SUBJECT: NRC SPECIAL INSPECTION REPORT 05000247/2000-010
STEAM GENERATOR TUBE FAILURE

Report No. 05000247/2000-010

Facility: Indian Point 2 Nuclear Power Plant

Indian Point 2 Nuclear Power Plant
NRC Inspection Report 05000247/2000-010

Figure 11 - Profile of Growth between 1997 and 2000

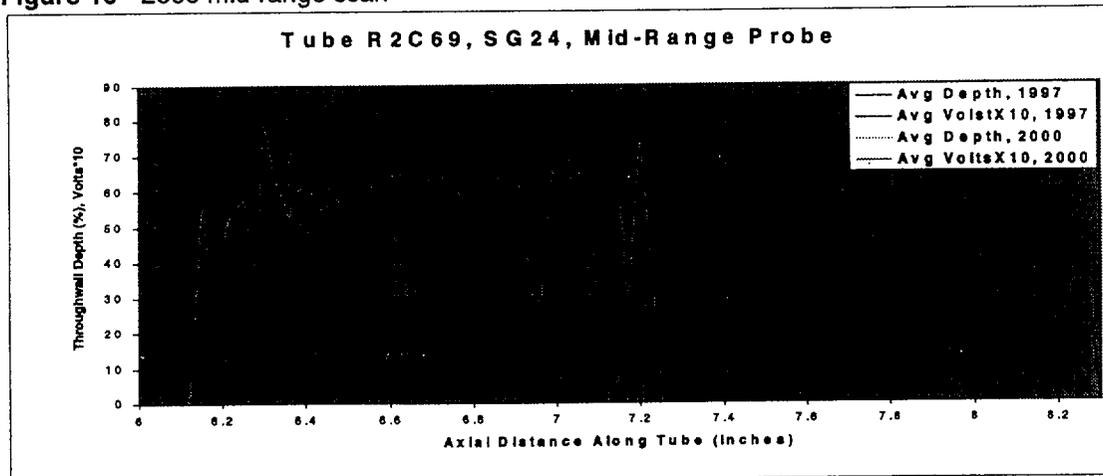
2. R2C69 in SG 24 - Figure 9 shows the c-scan plot for the 1997 data; there is considerable noise present. For comparison, the c-scan plot for the 2000 data is included as Figure 10. The noise features between the 1997 and 2000 data are similar enough to verify that this is the same defect at the same location. Figure 11 shows the profile. The defect voltage is only about 1 volt, and there is a considerable amount of noise on the tube, relative to the defect signal. The depth estimate based on 1997 data is 52.6% TW.

Figure 12 - 1997 scan

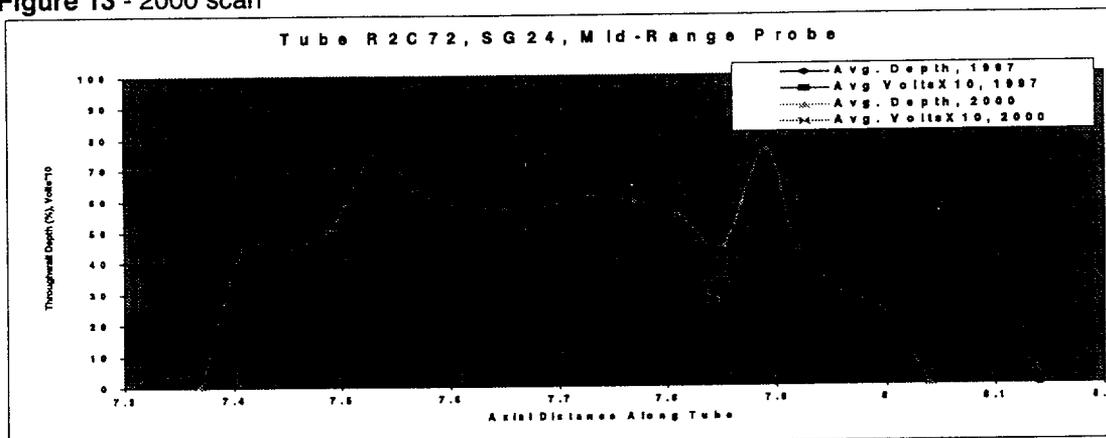
3. R2C72 in SG 24 - Figure 12 shows the c-scan plot of the 1997 data; there is considerable noise present. The crack is sitting in a ridge of noise, and barely extends above a ridge of deposits. For comparison the c-scan plot for the 2000 data is included as Figure 13. Figure 14 shows the profile. The crack barely extends above a 1-volt amplitude for a short length, and this is the only part of the crack that we can profile reliably. The depth estimate based on 1997 data is 79.2% TW.
